To: **Planning Reps**

From **Highways Development Management Officer**

Application Number 20211236

Location;- 11 Norah Lane Higham Rochester Kent ME3 7EP

Google Street View October 2009.

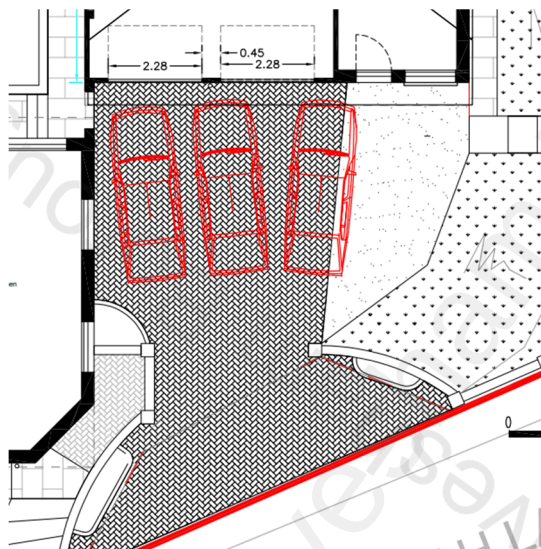
Three parking spaces are shown, but the space required extends beyond the existing blocked paved area and access is constrained by the existing gated access.

As such I do not believe the readily accessible requirement for all three parking spaces is met. I also note that the gates open outwards which is unacceptable in highway terms as vehicles have to wait on the highway whilst they are opened or closed. If they opened inwards which would be a requirement if agreement were possible, the gates would conflict with at least one of the parking spaces.
